Reviewers' Comments:

Manuscript ID: NCOMMS-18-23000A
Paper title: A Cavity-enhanced Fourier Transform Spectrometer with High Resolution and Large Bandwidth in Single Chip Solution
Authors: S.N. Zheng, H. Cai, J. F. Song, L. K. Chin, P. Y. Liu, Z. P. Lin, D. L. Kwong, and A. Q. Liu

Paper title: A Microring Resonator-assisted Fourier Transform Spectrometer with Enhanced Resolution and Large Bandwidth in Single Chip Solution

Supplementary Fig. S15: Thermal response time of **a** tunable MZI and **b** tunable MRR.

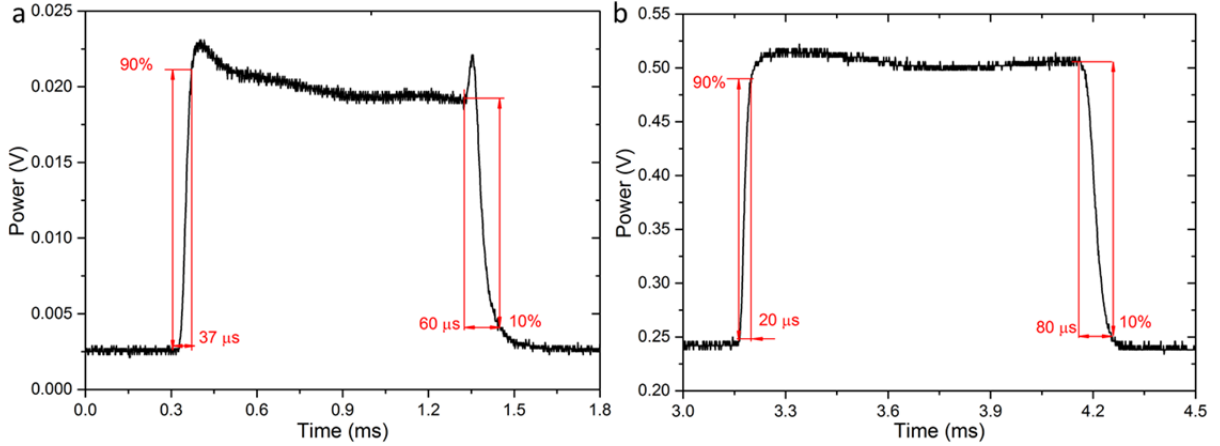
Comment 1: *In fact as the Q of the MRR filter increases to achieve high spectral resolution, the fraction of power contained in the output comb of the MRR filter decreases leading to decrease in the detector's SNR and corresponding dynamic range. More specifically, the authors need to quantify the loss in multiplex advantage incurred by the tuning mechanism.*

Reply: As pointed out by the reviewer, time spent for measuring a single resolution element is $\delta\lambda/\text{FSR} \approx 2\%$ before the MRR is tuned to scan. The experimental measurement of thermal responses of MZI and MRR are added to revised Supplementary Note 4 and the thermal response time of MZI and MRR are shown in Supplementary Fig. S15. The analysis on influences of time-multiplexing is added to revised manuscript as “Time-multiplexing will also induce extra power consumption due to multiple scans of MRR and MZI. Nearly 2% ($\delta\lambda/\text{FSR}$) of total time is spent for measuring a single resolution element and in our current experiment, the one-time scan duration is 2 s. The time-scale measurement on thermal response time of MZI and MRR is presented in Supplementary Note 4. The results show that the maximum sweeping frequency of MZI is 10 kHz. For 10 kHz sampling frequency and 2,000 one-time sampling points, the one-time scan duration is reduced to 0.2 s and the total time is reduced to $0.2\text{FSR}/\delta\lambda \approx 11.4$ s. Hence, the fast sweeping frequency of MZI will compensate the gain loss due to time-multiplexing and reduce the total energy consumption of MZI and MRR.” in Line 309 Page 15.

Supplementary Fig. S11: **a.** Schematic of MZI testing structure with isolation trenches. **b.** SEM image of the cross section of the thermal isolation trench. **c.** Power consumption vs gap between the trench and waveguide.

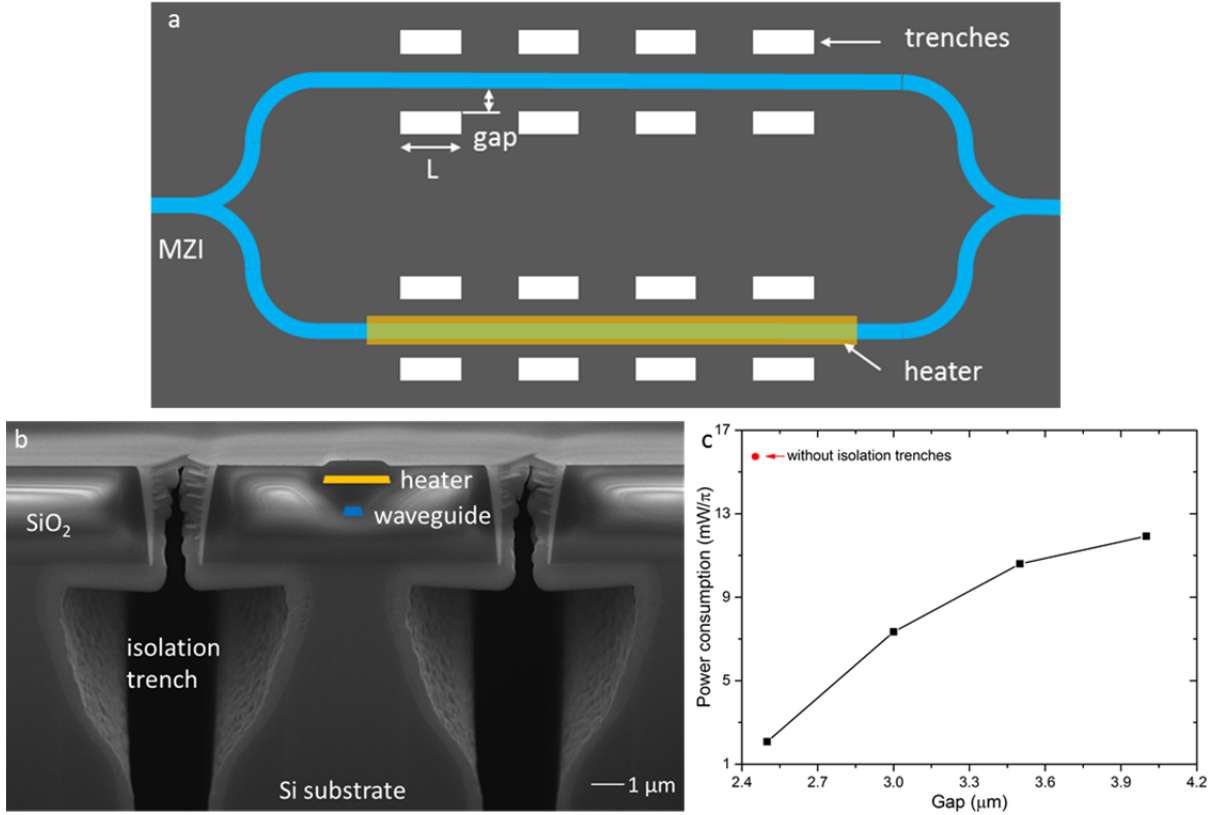
Comment 2: *The power consumption of the device is very high. Maybe a total energy is a better parameter, for example, with time to tune 100 usecs, the ring based spectrometer will consume about $35\text{mW} \times 140 \times 10^{-4} \text{sec} = 0.5\text{mJ}$ whereas the current device will consume about $1.8 \times 140 \times 10^{-4} = 25\text{mJ}$. This is a great penalty. This is a great penalty. In terms of power consumption, both a pure coupled ring resonator spectrometer, and a pure FTIR spectrometer are superior to this design*

Considering the power consumption of MZI, we can employ isolation trenches near MZI arms in the chip fabrication to improve the heating efficiency. MZI testing structures (Supplementary Fig. S11a) are fabricated to test the influence of isolation trenches on heating efficiency. The measurement and results are added to revised Supplementary Note 3. The heating efficiency can be improved to maximum 12 times by either reducing the gap and/or increasing the trench segment length L . The maximum heating power can be reduced to $1.8/12 \text{ W} = 150 \text{ mW}$ and the total consumed energy of MZI can be reduced to $P_{m\text{-total}}/12 = 5.6$ J. The consumed power is significantly decreased compared to other silicon-based thermally tunable MZI as in [26] in the reference. Besides, it can be further reduced (~ 8.75 times) when the waveguides are fully suspended referring to [31] in the reference.

The discussion on power consumption is added to revised manuscript as “The total energy consumed by MRR and MZI for N scans are 1.96 J and 67.2 J, respectively. The calculation is presented in Supplementary Note 3. The power consumption of MZI can be reduced to 150 mW through fabrication of isolation trenches along the waveguides of MZI arms (see Supplementary Note 3). Hence, the total energy consumed by MZI can be reduced from 67.2 J to 5.6 J. Note that the Si substrate under the MRR in the tested RAFT spectrometer and the MZI arm in the testing structure is not totally removed (Supplementary Fig. S11b), the heating efficiency of both MRR and MZI can be further reduced (~ 8.75 times) if the waveguides are fully suspended^[31].” in Line 276 Page 14.

Fig. 6c: Normalized retrieved spectrum (black) with ASE broadband source input (red).

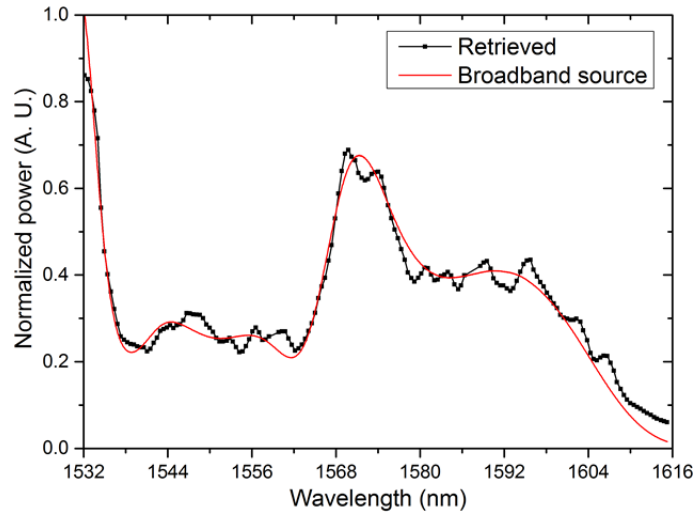
Comment 5: *Regarding the measurements, the experiments do not include a broadband signal measurement, only two fairly closely spaced narrowband laser lines are used for measurements. This is not sufficient to justify publication in high impact journal.*

Reply: As suggested by the reviewer, a broadband signal measurement is added to revised manuscript with the result shown in Fig. 6c. The description of measurement process and result is added to revised manuscript as “To further evaluate the performance of the RAFT spectrometer, we performed a broadband signal measurement. A broadband ASE light source (Amonics ALS-CL) covering C and L band is used as the input. For broadband signal input, all the detected input sparse spectra are retrieved using the normalization coefficient matrix A (see Supplementary Fig. S9) and are then combined to produce the original input spectrum. The retrieved spectrum and input broadband source are shown in the same figure (Fig. 6c) for comparison. The retrieved spectrum agrees with the input spectrum very well. The small discrepancy is due to misalignment between lensed fiber and inverse-taper waveguide coupler and resonance position variation due to thermal crosstalk. By packaging the lensed fiber to the input waveguide, the misalignment would not be present. The thermal crosstalk mainly originates from silicon substrate since the buried oxide layer (BOX) is not thick

enough to effectively isolate the heat from the heater above the MZI to Si substrate (as in our experiment, the BOX is 2 μ m). The residue thermal crosstalk can be mitigated through fabrication and optimization of isolation trenches near MZI arms. It will also be reduced by making both MRR and MZI fully suspend and/or using thicker BOX. Moreover, it will be well compensated with a feedback control circuit.” in Line 253 Page 13.

Supplementary Fig. S2a: Relation between the static temperature and the heating power with and without trenches.

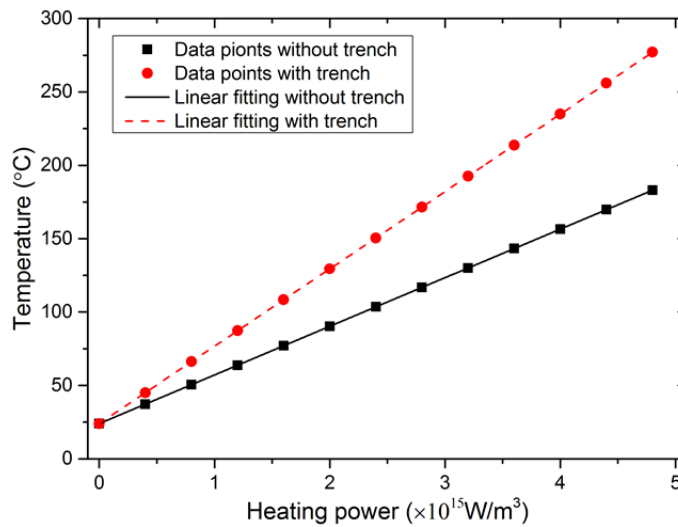
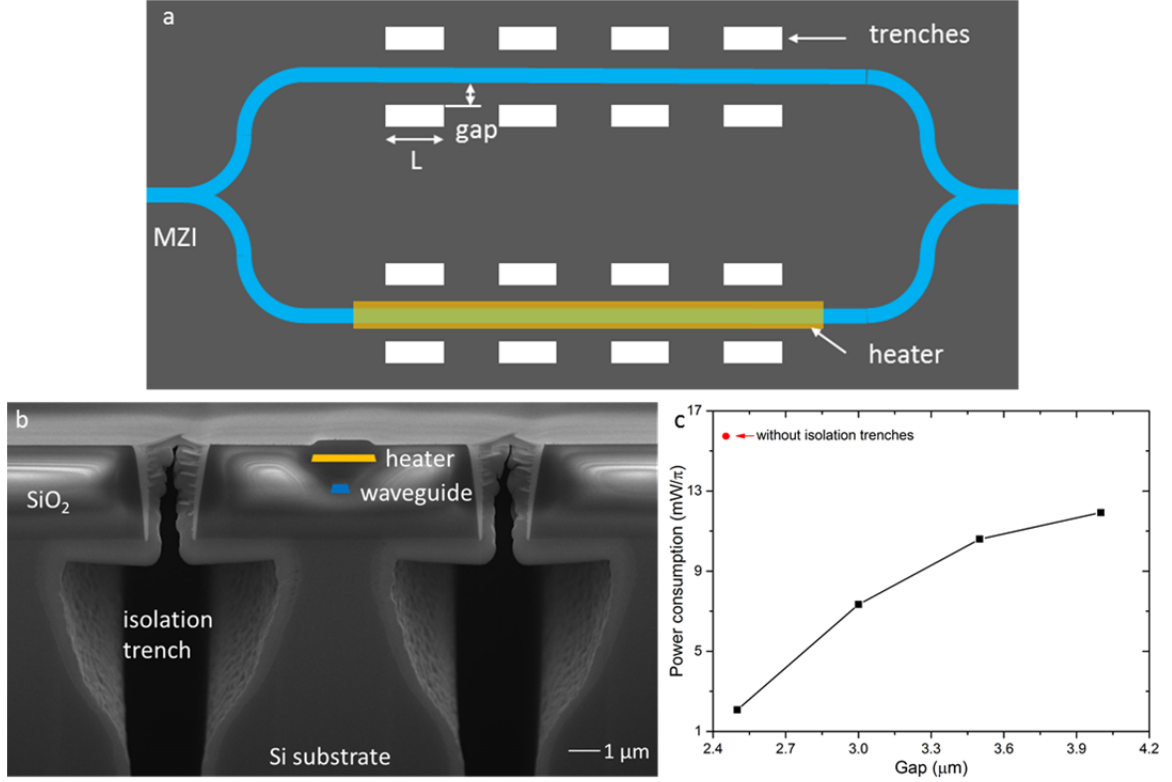
Comment 2: *The authors mention the heat isolation trenches to improve the heating/thermal optical effect efficiency. Thermal crosstalk between the MZ and the ring resonator is also a major problem, because the operation of the former might affect the resonance position of the ring resonator. This is not addressed neither theoretically nor experimentally in the manuscript*

Reply: As suggested by the reviewer, the simulation result of the isolation trenches to improve heating efficiency is presented in Supplementary Note 1 and shown in

Supplementary Fig. S2a. MZI testing structures (shown in Supplementary Fig. S11a) are fabricated to experimentally test the influence of isolation trenches on the heating efficiency and the results are added in revised Supplementary Note 3. The heating efficiency can be improved to maximum 12 times by reducing the gap and/or increasing the trench segment length L . The discussion on the heating efficiency improvement is added in revised manuscript as “The total energy consumed by MRR and MZI for N scans are 1.96 J and 67.2 J, respectively. The calculation is presented in Supplementary Note 3. The power consumption of MZI can be reduced to 150 mW through fabrication of isolation trenches along the waveguides of MZI arms (see Supplementary Note 3). Hence, the total energy consumed by MZI can be reduced from 67.2 J to 5.6 J. Note that the Si substrate under the MRR in the tested RAFT spectrometer and the MZI arm in the testing structure is not totally removed (Supplementary Fig. S11b), the heating efficiency of both MRR and MZI can be further reduced (~ 8.75 times) if the waveguides are fully suspended^[31]” in Line 276 Page 14.

Fig. 6c: Normalized retrieved spectrum (black) with ASE broadband source input (red).

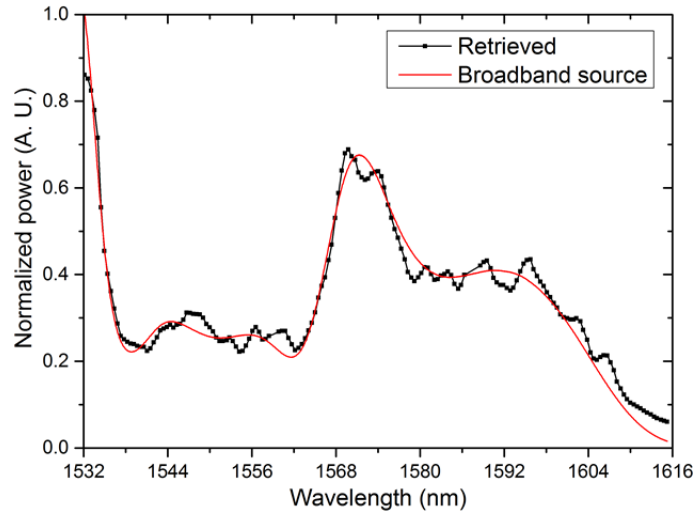
4.3) *The authors mention that under a single wavelength input one observes a sinusoidal behaviour of the photodetector current, as shown in Fig. 5a. The behaviour is absolutely not sinusoidal. There is a large amplitude variation, plus, although not shown, there should be chirp which would explain the large difference between the retrieved spectrum with respect to the input. This may not appear to be a big problem when a source with only one or two wavelengths are employed. However, this would make the device unusable for a continuous reconstruction. This is the most serious negative issue of this manuscript. There should be a demonstration of a wide spectrum recovery. Based on the results for single or double wavelength, it appears that the non-linearities that I commented above, if not considered and taken care of, will make the device unusable. Therefore, a better evaluation of the non-linearity and a demonstration of a wide spectrum recovery is paramount for the demonstration of the device functionality*

As suggested by the reviewer, we have performed the wide spectrum measurement as shown in Fig. 6c. The description of measurement process and result is added in revised manuscript as “To further evaluate the performance of the RAFT spectrometer, we performed a broadband signal measurement. A broadband ASE light source (Amonics ALS-CL) covering C and L band is used as the input. For broadband signal input, all the detected input sparse spectra are retrieved using the normalization coefficient matrix A (see Supplementary Fig. S9) and are then combined to produce the original input spectrum. The retrieved spectrum and input broadband source are shown in the same figure (Fig. 6c) for comparison. The retrieved spectrum agrees with the input spectrum very well. The small discrepancy is due to misalignment between lensed fiber and inverse-taper waveguide coupler and resonance position variation due to thermal crosstalk. By packaging the lensed fiber to the input waveguide, the misalignment would not be present. The thermal crosstalk mainly originates from silicon substrate since the buried oxide layer (BOX) is not thick enough to effectively isolate the heat from the heater above the MZI to Si substrate (as in our experiment, the BOX is 2 μm). The residue thermal crosstalk can be mitigated through fabrication and optimization of isolation trenches near MZI arms. It will also be reduced by making both MRR and MZI

fully suspend and/or using thicker BOX. Moreover, it will be well compensated with a feedback control circuit.” in Line 253 Page 13.

Fig. 6c: Normalized retrieved spectrum (black) with ASE broadband source input (red).

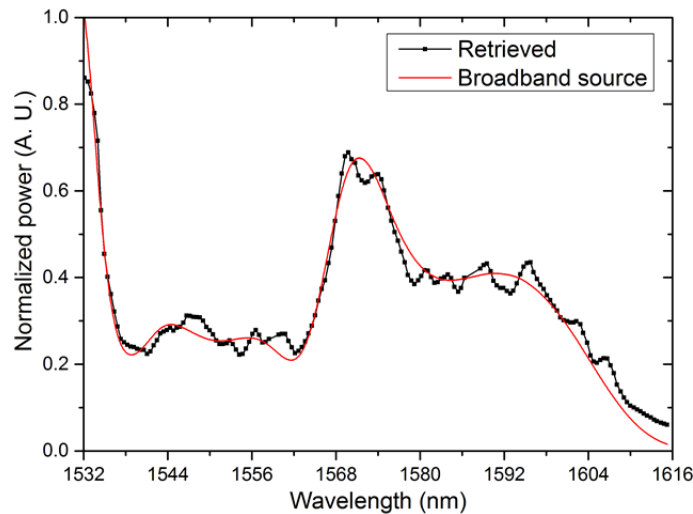
Comment 2: *Although the idea of the authors in cascading a MRR with a MZI to increase the spectral resolution seems to be novel, unfortunately they fail to demonstrate this enhancement in practice. In Fig. 4 (a) the authors show the transmission spectrum of the MRR with ~ 0.5 nm FWHM, measured with an optical spectrum analyzer, not the MZI. In Fig. 6 the measured spectrum of two cw laser sources (with a wavelength difference of ~ 30 nm) are shown and it is obvious from the figure that the spectral resolution of the spectrometer is ~ 20 nm. The authors do not demonstrate the possibility of resolving two spectral features with a separation in the order of their claimed resolution (~ 0.5 nm). In addition the process of extracting a high resolution broadband spectrum by their spectrometer is not explained and there is no comments about the time scale needed for performing such a measurement. The measurement time is specifically important since the performance of a heater-based spectrometer is compared with an AWG-based one (see [5-8]).*

As suggested by the reviewer, we have performed broadband source retrieval shown in Fig. 6c. The description of measurement process and result is added in revised manuscript as "To further evaluate the performance of the RAFT spectrometer, we performed a broadband signal measurement. A broadband ASE light source (Amonics ALS-CL) covering C and L band is used as the input. For broadband signal input, all the detected input sparse spectra are retrieved using the normalization coefficient matrix A (see Supplementary Fig. S9) and are then combined to produce the original input spectrum. The retrieved spectrum and input broadband source are shown in the same figure (Fig. 6c) for comparison. The retrieved

spectrum agrees with the input spectrum very well. The small discrepancy is due to misalignment between lensed fiber and inverse-taper waveguide coupler and resonance position variation due to thermal crosstalk. By packaging the lensed fiber to the input waveguide, the misalignment would not be present. The thermal crosstalk mainly originates from silicon substrate since the buried oxide layer (BOX) is not thick enough to effectively isolate the heat from the heater above the MZI to Si substrate (as in our experiment, the BOX is 2 μ m). The residue thermal crosstalk can be mitigated through fabrication and optimization of isolation trenches near MZI arms. It will also be reduced by making both MRR and MZI fully suspend and/or using thicker BOX. Moreover, it will be well compensated with a feedback control circuit.” in Line 253 Page 13.

Supplementary Fig. S16: Relation between Q value and self-coupling coefficient r .

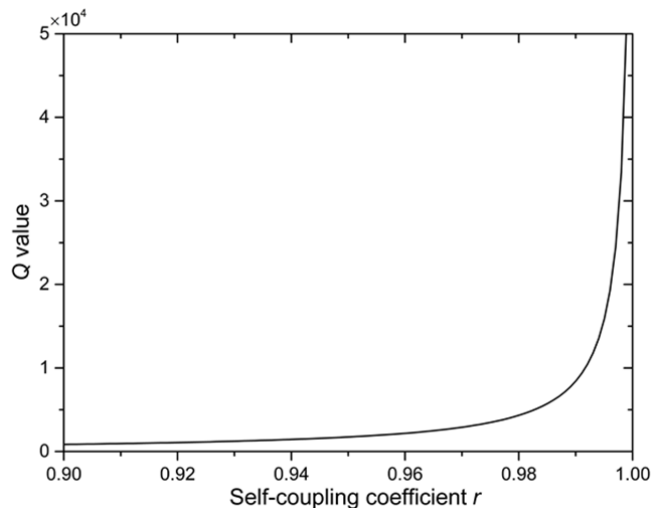
Comment 1: *The main problem with the evanescent couplers is their bandwidth of operation. Additionally, they have to be very finely controlled to get the small coupling coefficients that are needed to make high Q resonators. How Q will depend on the coupling coefficient and in turn what fabrication tolerance will need to be achieved?*

As suggested by the reviewer, the analysis and discussion on how Q depends on coupling coefficient are added in revised Supplementary Note 5 as

The Q value is proportional to r as shown in Supplementary Fig. S16. The values of each parameter in the simulation are shown in Supplementary Table S3.” in Line 295 Page 20.

Supplementary Fig. S2a: Relation between the static temperature and the heating power with and without trenches.

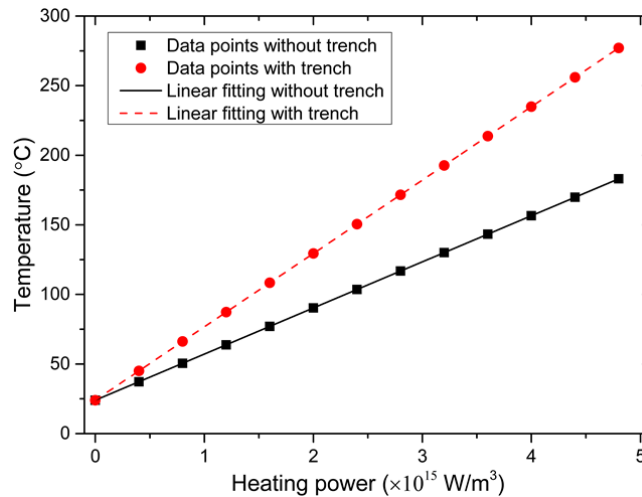
Comment 2: *Figure S2a has a typo: "piont"s instead of "points".*

Reply: As pointed out by the reviewer, the typo "pionts" is corrected as "points" in revised Supplementary Fig.S2a in Page 3.

Fig. 6a: Retrieved spectra with TLS-1 and TLS-2 (set at adjacent on-resonance wavelengths of MRR, respectively) input simultaneously when $\Delta\lambda = 0$.

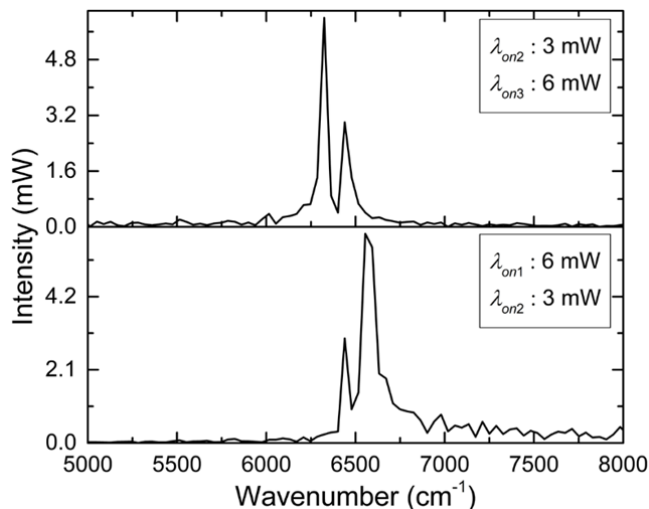
Comment 1: *The authors also managed to measure broadband spectrum of an ASE source in Fig. 6 (c) with, apparently, a spectral point spacing of ~ 0.5 nm. This is definitely a forward step in showing the capability of their instrument to measure a broadband spectrum; however, they again fail to demonstrate the possibility of resolving two spectral features with a separation in the order of their claimed resolution (~ 0.5 nm). The structures on the ASE spectral profile in Fig. 6 (c) (black curve) could be due to the artifacts that the authors mention in the revised manuscript and since the measured ASE spectrum in Fig. 6 (c) (red curve, which they compare their measurement to) is quite low resolution, it would not help to evaluate the spectral resolution of their instrument. I suggest the authors to re-measure the spectra shown in Fig. 6 (a) and (b) when the frequency of the two tunable laser sources are only separated by 0.5 nm and show the ability to resolve them.*

Reply: As pointed out by the reviewer, the working process of the microring resonator-assisted Fourier-transform (RAFT) spectrometer is that the tunable MZI distinguishes the sparse spectrum (3 resonance peaks) from MRR at each MRR tuning state. The intention is to verify that the resolution of the tunable MZI is sufficient to differentiate the sparse spectrum from MRR. The original spectrum is obtained by combining the reconstructed sparse spectra at all tuning states. The description and measurement results are modified in revised manuscript as “TLS-1 and TLS-2 (ANDO AQ4321D) are combined with a 50/50 optical coupler as the input for double wavelength characterization. Figure 6a shows the retrieved spectra when TLS-1 and TLS-2 are set at adjacent on-resonance wavelengths. The tuning state is resonance wavelength shift $\Delta\lambda = 0$. The resonance wavelengths are $\lambda_{on1} = 1525.400$ nm, $\lambda_{on2} = 1552.844$ nm, and $\lambda_{on3} = 1581.240$ nm, respectively. One can see that the two adjacent on-resonance wavelength components can be easily distinguished and reconstructed by the tunable MZI. As a result, the tunable MZI can retrieve each filtered spectrum at each tuning state of the MRR.” in Line 242 Page 12.

Fig. 6c: Normalized retrieved spectrum (black) with a broadband source (red) input. The source spectrum is generated from an optical fiber interferometer.

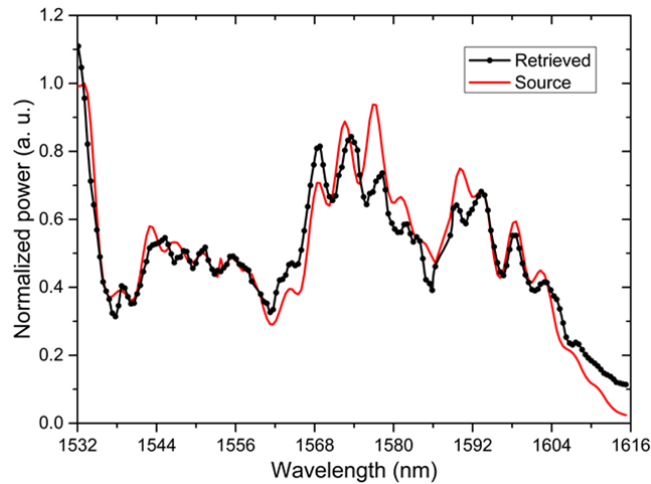
Comment 2: *In addition, to show that the instrument can offer this spectral resolution for the entire 90 nm bandwidth (as they claim in the abstract), I suggests the authors to measure a broadband absorption spectrum of a (or multiple) gas species, e.g. CO₂. The fine absorption lines of gas phase species are spread around in a broad spectral range, which would nicely verify the performance of the “spectrometer with enhanced resolution and large bandwidth”, as it is claimed in the title of the manuscript.*

Reply: As suggested by the reviewer, we measured a broadband absorption spectrum of CO₂. Unfortunately, we found that there are no such sharp absorption peaks by CO₂ or other gas

species in the working range of the spectrometer (1530-1620 nm), because the absorption peaks in near infrared range are normally broad and weak due to overtones of N-H, O-H and C-H bonds. By referring to [27] and [31], we use an optical fiber interferometer to produce a broadband spectrum with multiple peaks (2-6 nm wavelength separation) across the entire bandwidth of the RAFT spectrometer as the input broadband spectrum. We replaced the previous experimental results with the improved results as shown in Fig. 6c. The descriptions on the measurement and results are added in revised manuscript as “Furthermore, we performed a broadband signal measurement with the minimum MRR tuning value of 0.47 nm. The transmission spectrum from an optical fiber interferometer is used as the input. For broadband signal input, all the detected input sparse spectra are retrieved using the normalization coefficient matrix A (see Supplementary Fig. S9) and are then combined to produce the original input spectrum. The normalized retrieved spectrum and input broadband source are shown in Fig. 6c. The retrieved spectrum agrees well with the input spectrum. The small discrepancy is due to misalignment between lensed fiber and inverse-taper waveguide coupler while heating MZI. Another reason is resonance position fluctuation due to thermal crosstalk (see Supplementary Note 3).” in Line 257 Page 13.

Supplementary Figure S17: **a** Simulated relation between transmitted power carried by the filtered sparse spectrum ($m = 3$) and resolution. **b** Simulated relation between SNR and resolution at different input power values.

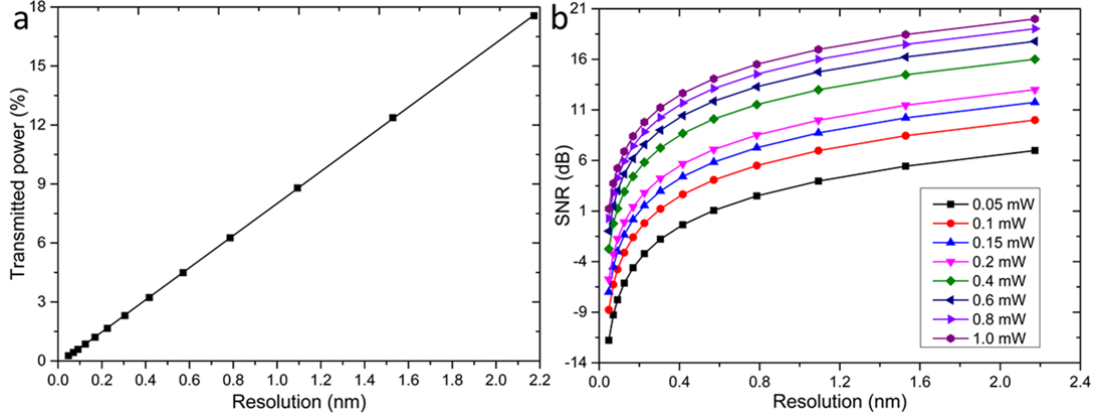
Comment 2: *Just stating that “SNR degraded by time-multiplexing” and that it “ can be improved by reducing optical loss and/or adopting smaller FSR” is not answering the concern. I would expect some quantitative relation between the resolution and SNR requirement, especially when dealing with broad bandwidth signals. After all, you want to extract enough power through the filter but at the same time the total broad band signal power has to be transmitted through waveguides and not cause TPA, etc.*

Reply: As suggested by the reviewer, quantitative analysis on SNR and resolution is added in revised Supplementary Note 5 as
